The City of Spartanburg Design Review Board

AGENDA

PROJECT/ADDRESS/ TAX IDSpartanburg Hudson Automotive Parking / 400 E Daniel
Morgan Ave / 7-12-06-061.00**PROJECT NUMBER**

The existing Spartanburg Subaru dealership is proposing the addition of an accessory structure to serve as an auto detailing area, along with an expanded 126-space parking lot. The project also includes new landscaping and streetscape enhancements. This application is for Preliminary Review.

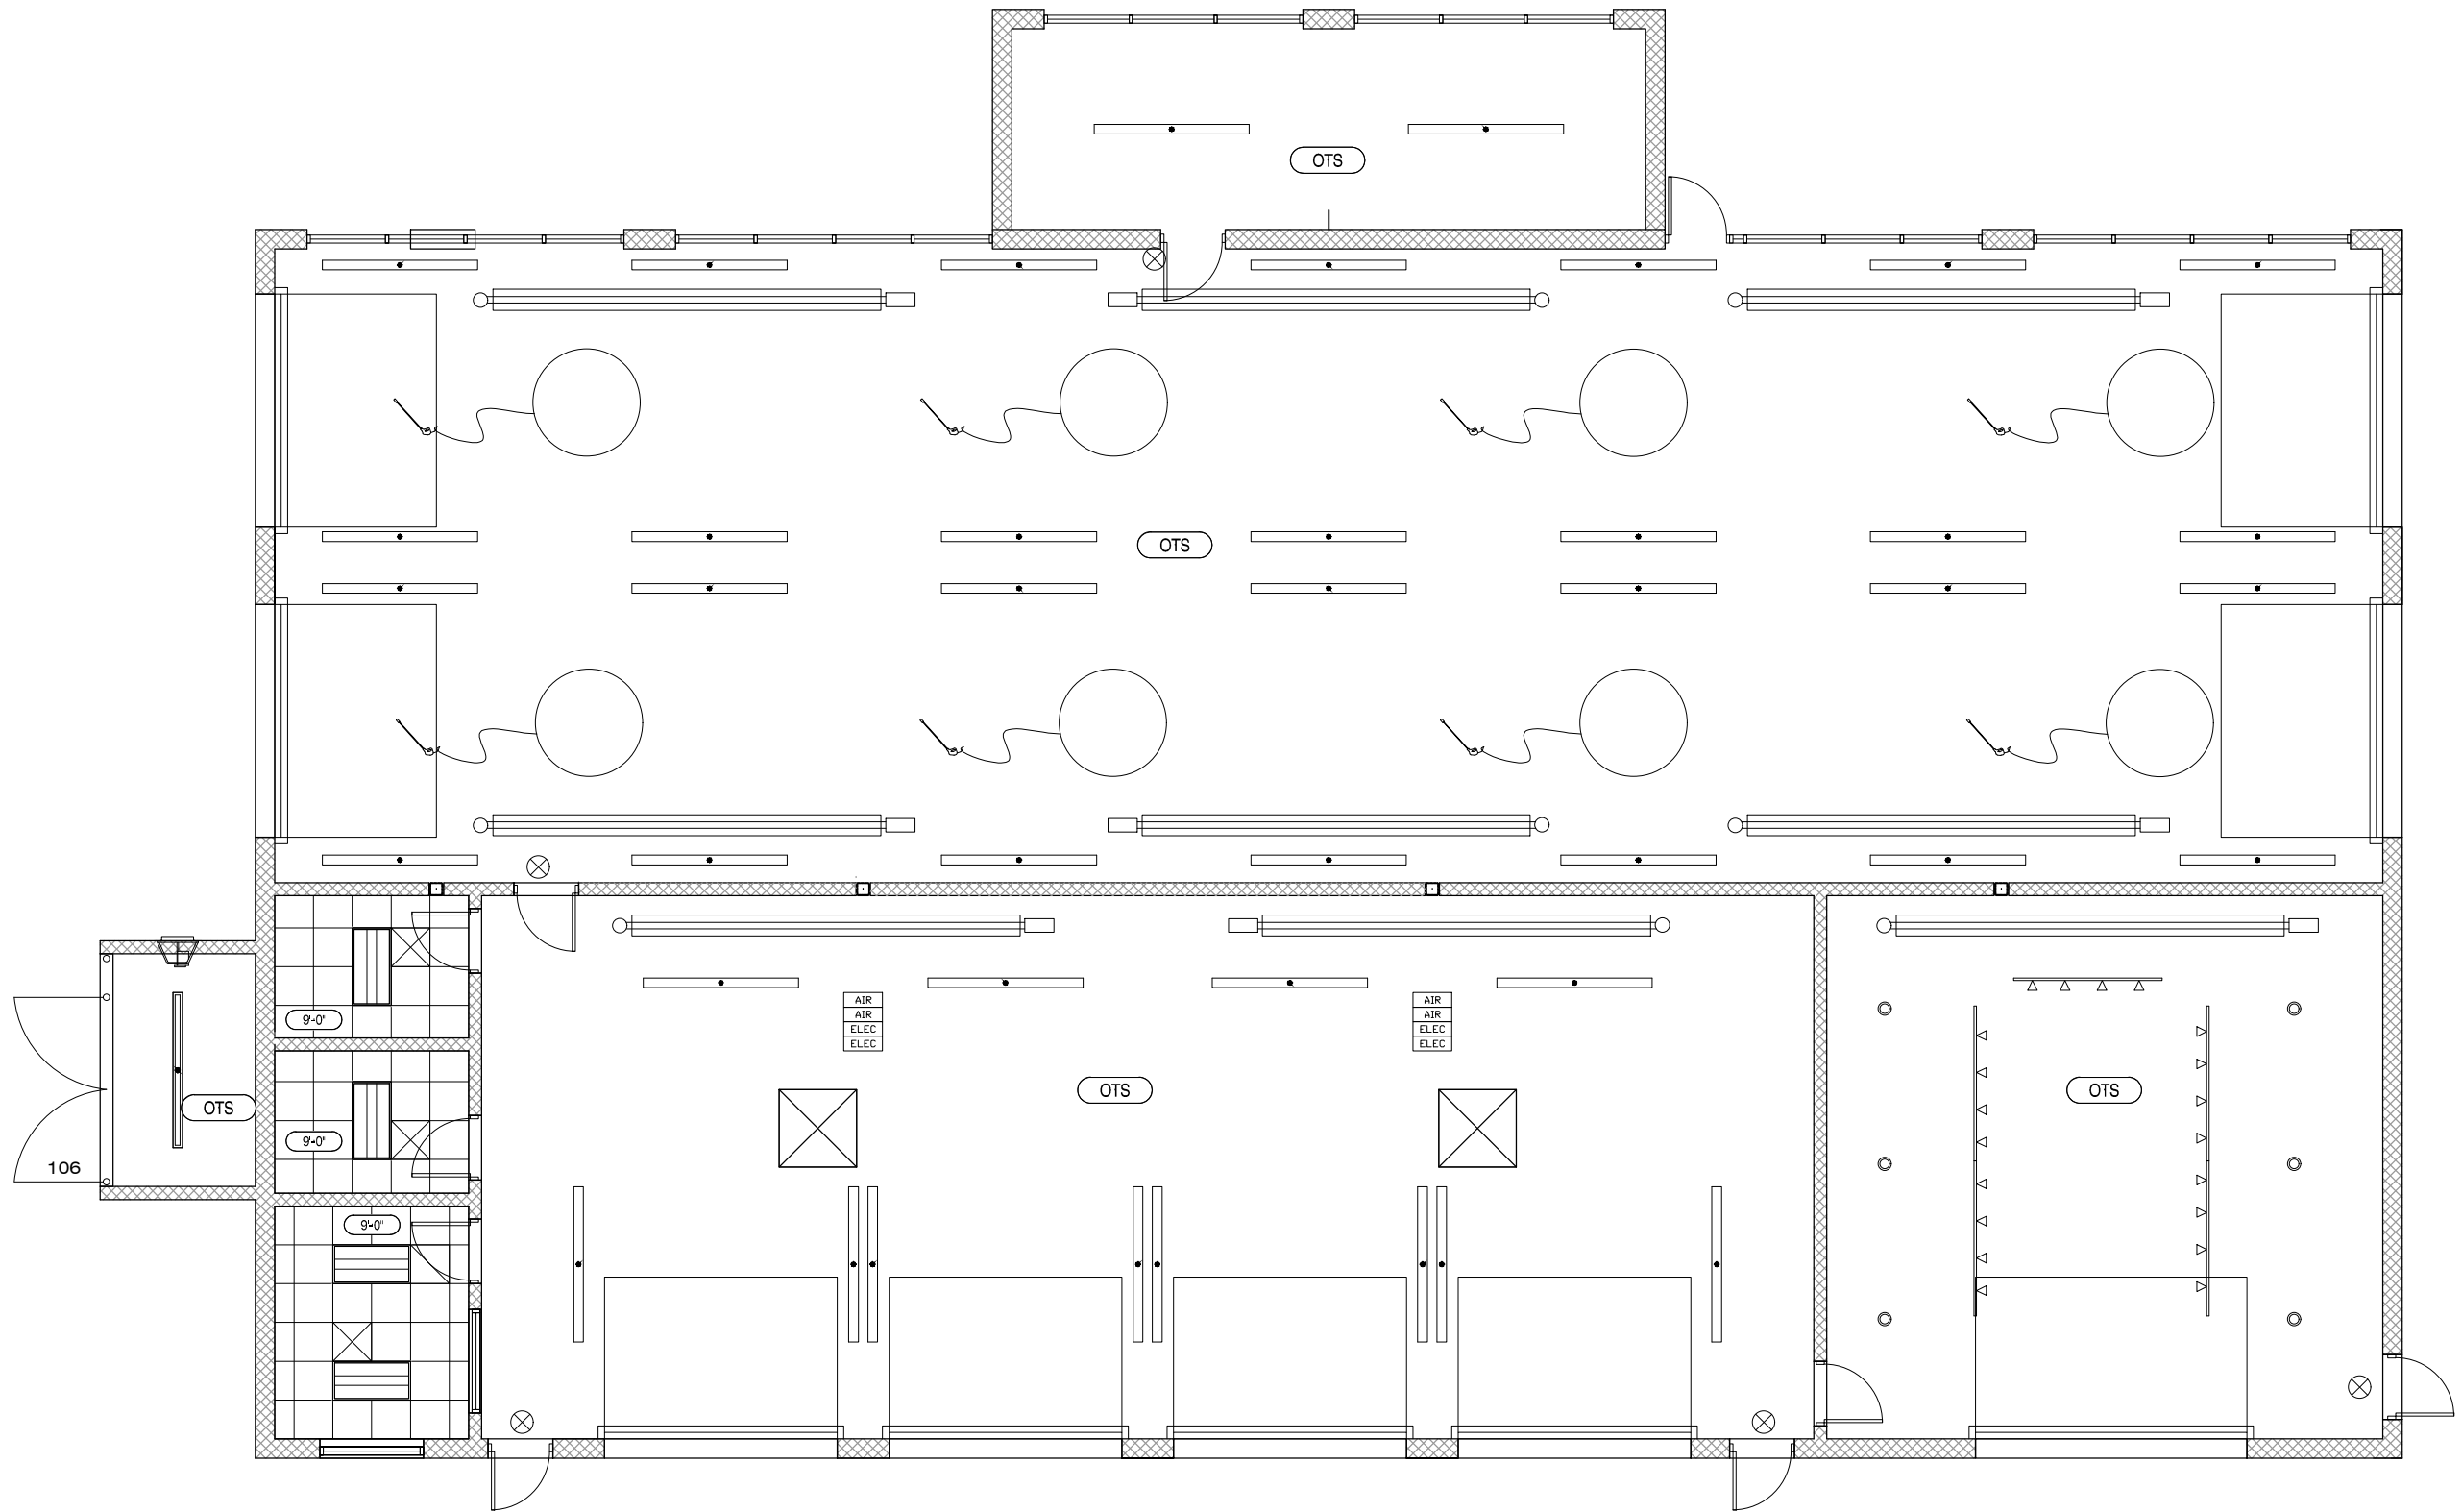
- **6.4.3 Encroachments:** *Not Applicable*
 - **6.4.4 Ground Level Detailing:** *More detail requested – opacity of front facing windows should be in the range of 25-35% to allow sufficient passing of light and movement, but not full transparency into car wash/detail area.*

- **6.4.5 Materials:** *Exception Required – The proposed project uses a metal paneling system to match the adjacent car dealership.*
